# **Louth County Council**

# Ardee Main Street, Co Louth

Preliminary Design Report

Stage 2 Road Safety Audit

Drawing HDC1256 107 Rev 07, South of Dee River bridge.

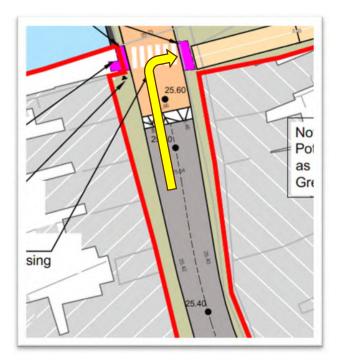
There is no provision for northbound cyclists to exit the N2 and wait to cross the signalised crossing. Cyclists will therefore continue travelling northbound on the Main Street carriageway thereby increasing the risk of collisions with general traffic. A proposal to direct cyclists via Hale Street was suggested in the Feedback Form of the Stage 1&2 Road Safety Audit. That proposal does not appear to be included in this design update.

Drawing HDC1256 107 Rev 07, South of Dee River bridge.

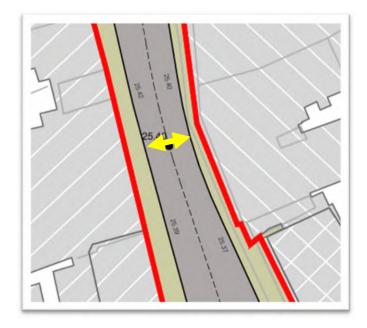
There is a pinch point in the carriageway south of the bridge. Wide vehicles currently operate an informal shuttle system to pass each other. This may not be possible with the introduction of the new crossing as vehicles may be stuck in position while queuing at the signals. This could lead to side-swipe collisions, damage to bollards and mounting of the footpath. It is noted from the site visit that queuing on the N2 is common for long periods of each day. (It was observed during the most recent site visit that flexible bollards in the footpath at this location have been struck many times and have collapsed)

It is recommended that an analysis be carried out of the likelihood of queues at the pinch point and the possible need for a longer formal shuttle system.

Drawing HDC1256 106 Rev 06, Ash Walk, tie in with link road to the N52.

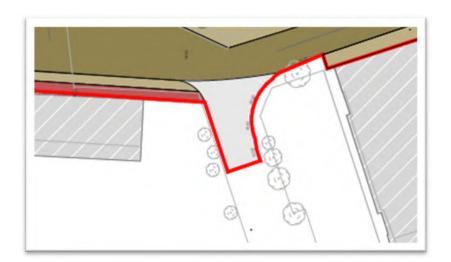
The link road to the N52 from Ash Walk is not shown to be a shared street. A change of street type could increase the risk of collisions with vulnerable road users.

Drawing HDC1256 1002 (K) Rev 03 Kerb Layout, Access to private garage off N2.

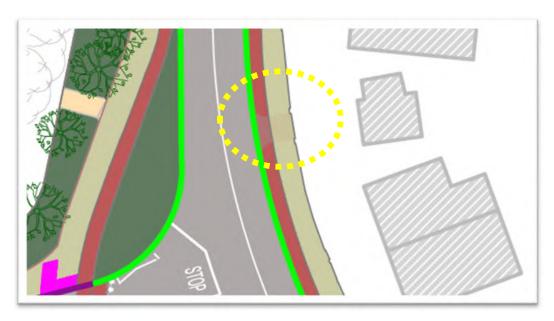
The drawing shows a 125mm high kerb at the proposed vehicular access to the private garage on the eastern side of the N2 just north of the Golf Links Road junction. A high kerb could lead to vehicles 'bouncing back' when trying to access the driveway to the garage resulting in rear-end collisions.

It is recommended that the kerb height be adjusted to facilitate vehicular access.

Paragraph No. in Safety Audit Report (Stage 2)	Measures undertaken to Address the Item
3A.1	Kerbs have been amended to reflect the audit item.
3A.2	Arrangement has been amended to reflect the audit comment and an additional crossing point on the cycle facility provided.
3A.3	Tactile paving have been amended to reflect the audit comment.
3A.4	Kerbs have been amended to reflect the audit item.
3A.5	Kerbs have been amended to reflect the audit item.
3A.6	Tactile paving have been amended to reflect the audit comment.

Drawing HDC1256 1002 (K) Rev 03 Kerb Layout, Relocated Bus stop and bus shelter, south bound.

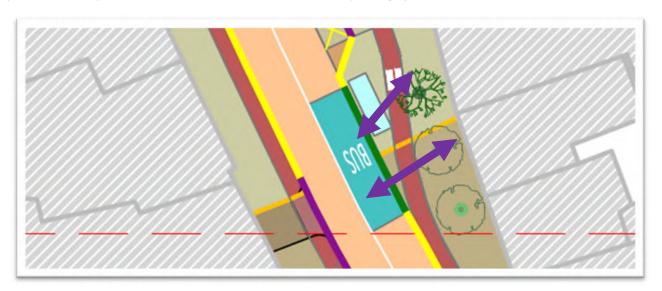
It is recommended that the layout be changed to provide adequate space for bus users without conflict with cyclists.

Drawing HDC1256 1002 (K) Rev 03 Kerb Layout, Zebra Crossing.

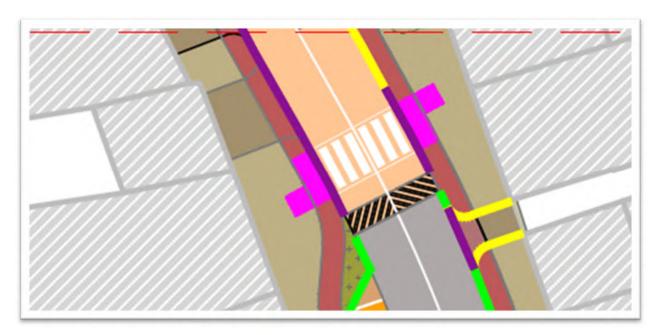
It is recommended that a shared use area be developed at both sides of this zebra crossing and other similar crossings.

Drawing HDC1256 1002 (K) Rev 03 Kerb Layout, Flush Kerbing.

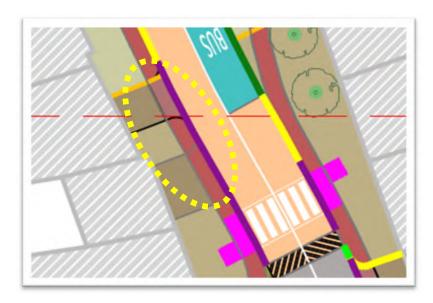
It is recommended that flush kerbs only be provided at crossing points or access areas for pedestrians only.

Drawing HDC1256 1002 (K) Rev 03 Kerb Layout, 50mm high kerbing at accesses.

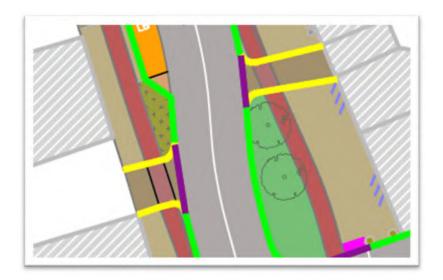
It is proposed to provide 50mm high kerbing at some accesses across the footpath. This would be a trip hazard and would lead to inaccessibility for mobility impaired pedestrians.

It is recommended that flush kerbs be used or no kerbs and that continuous footpath and cycle track facilities be used.
